**(ANNOTATED SHEETS SHOWING CHANGES OF FIGS. 6, 9, 13, & 16,
AND REPLACEMENT FORMAL DRAWINGS OF FIGS. 6, 9, 13, & 16)**

(Serial No. 10/613,277)

IN THE DRAWINGS:

FIG. 6

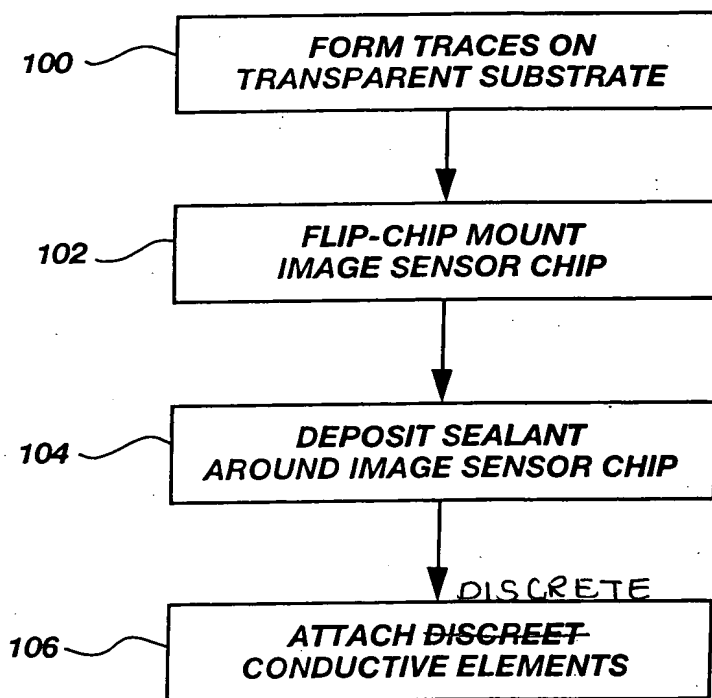
The attached sheets of drawings include changes to FIGS. 6, 9, 13, and 16. The word "DISCREET" has been corrected to "DISCRETE." The sheets, which include FIGS. 5, 6, 9, 10, 13, and 16, replace the original sheets including FIGS. 5, 6, 9, 10, 13, and 16.
